## **River Bend September 2004 NRC Written Exam Analysis**

Following the administration and preliminary grading of the River Bend September 2004 NRC Written Examinations, an exam analysis was completed by the River Bend Training Department with input from the applicants and exam developer in accordance with NUREG-1021, ES-403. The attached table contains the results of the analysis of both written exams in terms of questions missed by each candidate and the INCORRECT answer chosen. The Analysis Comments column summarizes the results of the detailed review of those questions that half or more of the Reactor Operator and/or Senior Reactor Operator candidates missed. The validity of the question and accuracy of the answer key were reviewed for each of those questions.

Questions 7, 18, and 60 are being submitted for deletion from the exam following the exam analysis. All three were found to have no correct answer. Each question is attached following the exam analysis table with justifications for removal and supporting reference materials.

ERIS Screen Printouts for Full Power, Hydraulic ATWS, and successful scram conditions.

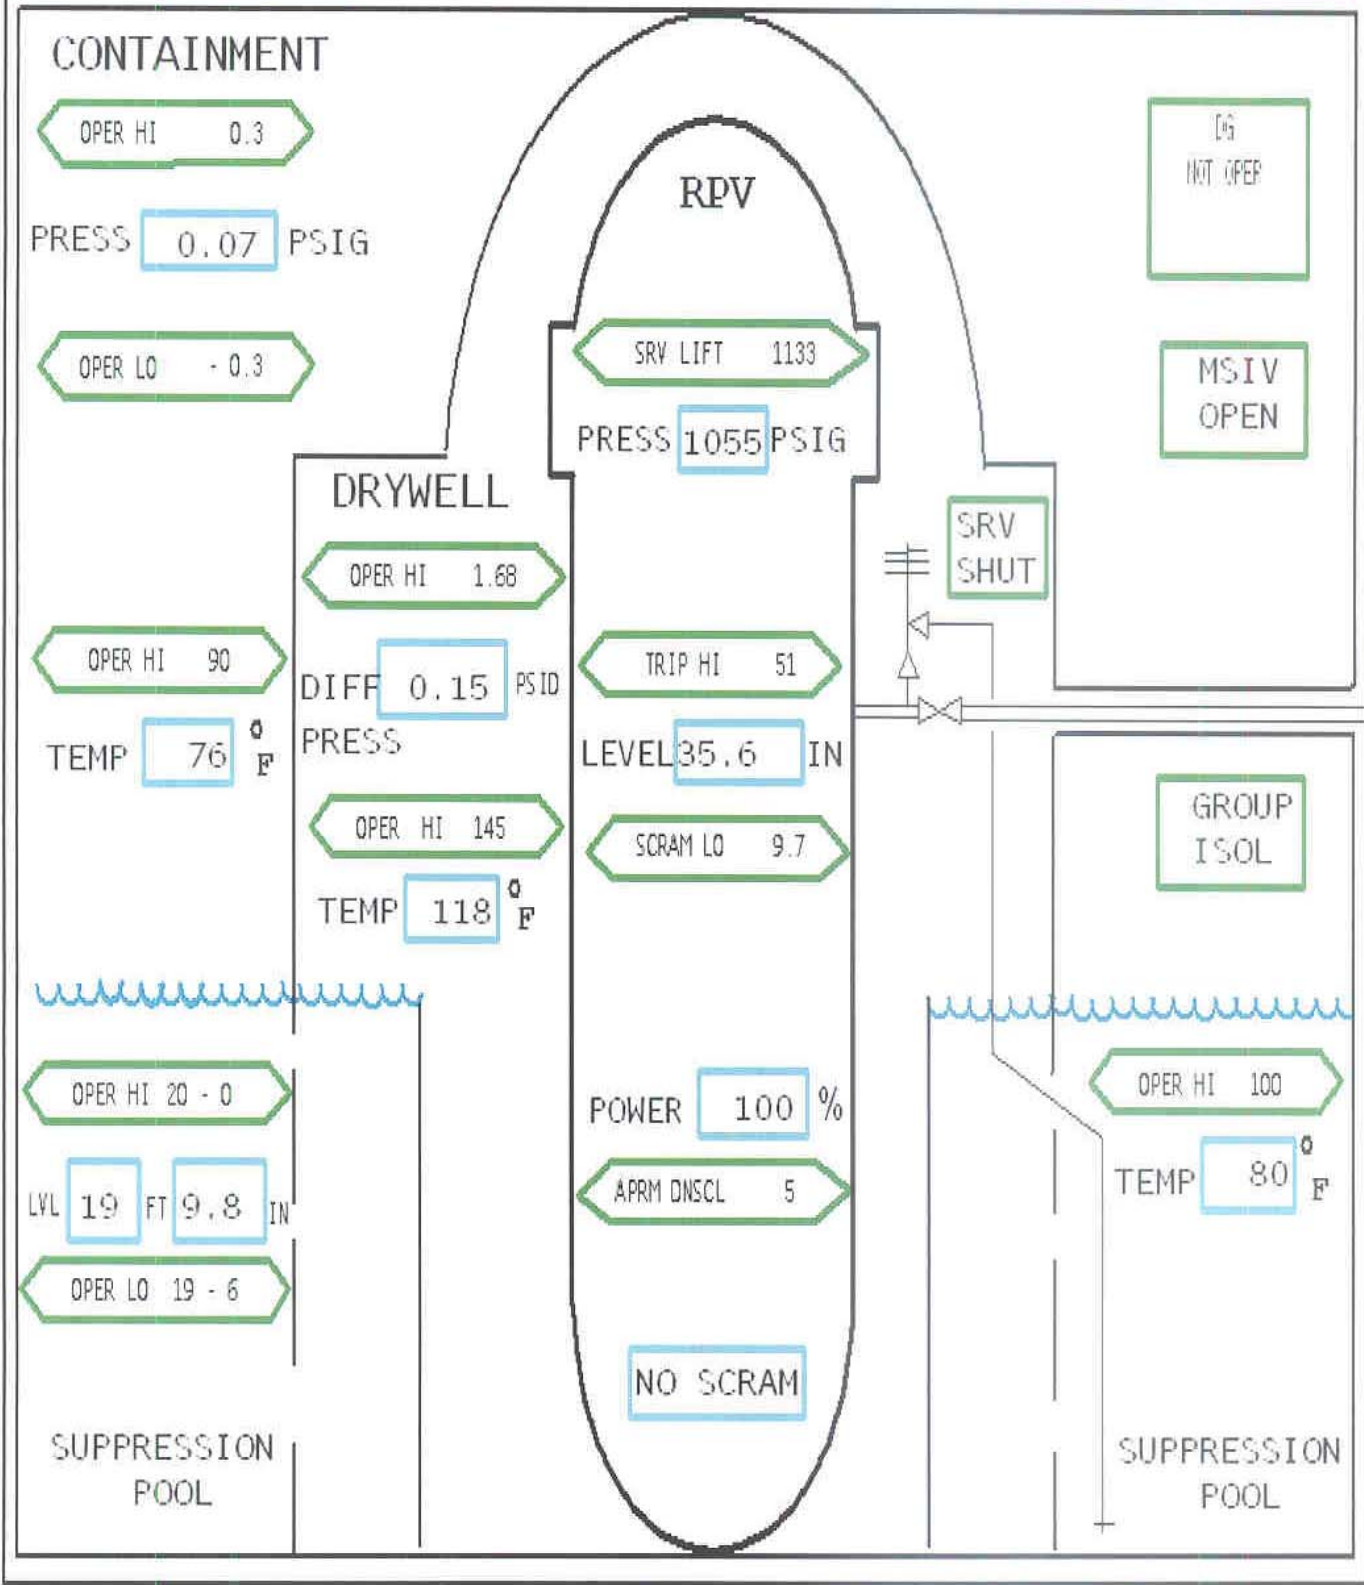
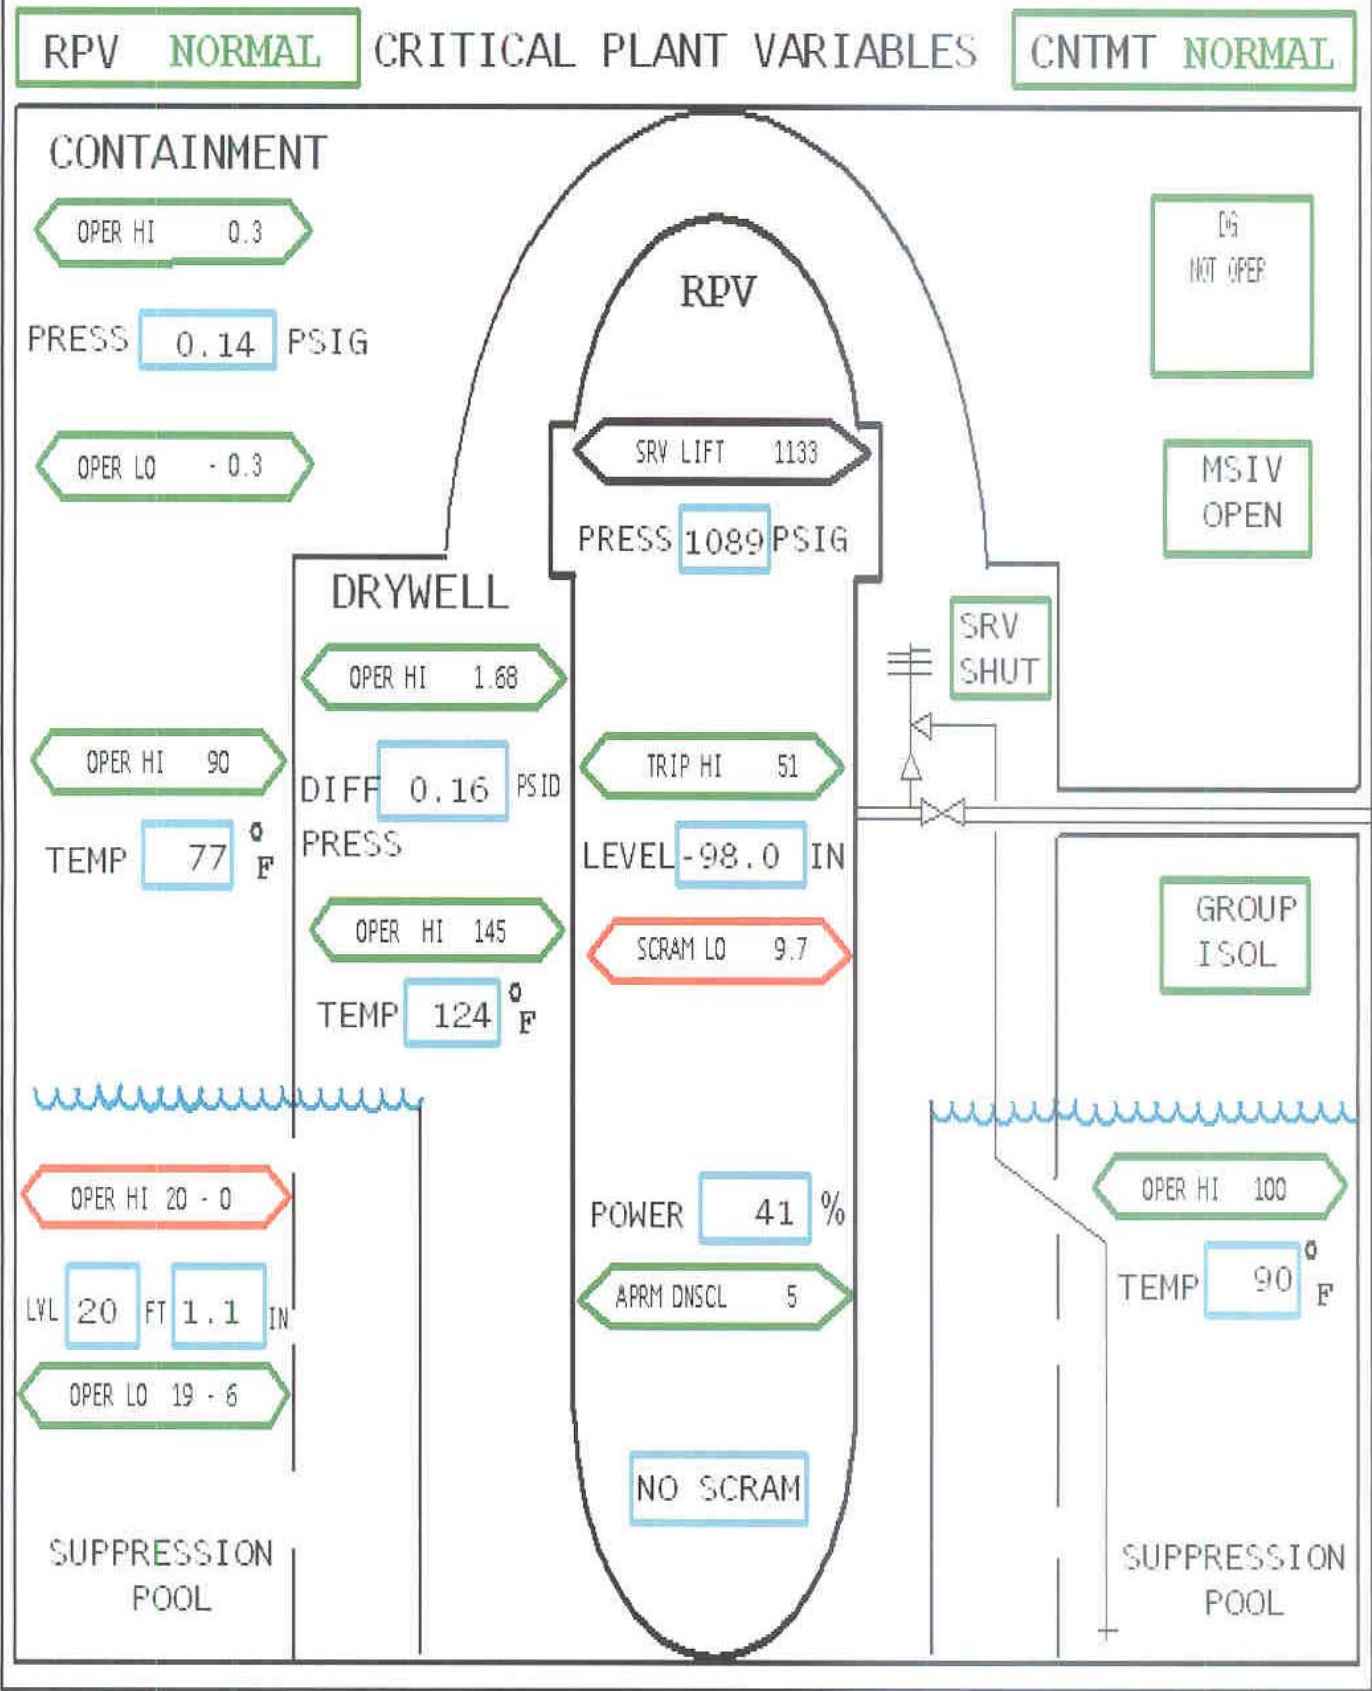
The correct answer per the KEY for this question was choice B. It is correct that NO SCRAM will be displayed. However, the highlight box around the NO SCRAM status box is colored cyan (light blue), NOT green as is the case for other status boxes on ERIS, such as MSIV status and GROUP ISOL status.

No change in color occurs and the highlight box remains cyan colored. The only other state for this box is when scram conditions are detected (One of the RPS K14 relays in each RPS trip system de-energized and all control rods at position '00') when the displayed status will change to SCRAM in red lettering and the highlight box changes to red.

Attached are ERIS screen printouts from the simulator showing the status of this parameter 1) at rated power, 2) following a hydraulic ATWS and 3) following a normal successful scram.

Therefore, the only correct answer for this question was that the status box would be NO SCRAM highlighted in cyan or light blue which was not provided as a choice.

DELETE the question from the exams because there is NO CORRECT ANSWER.
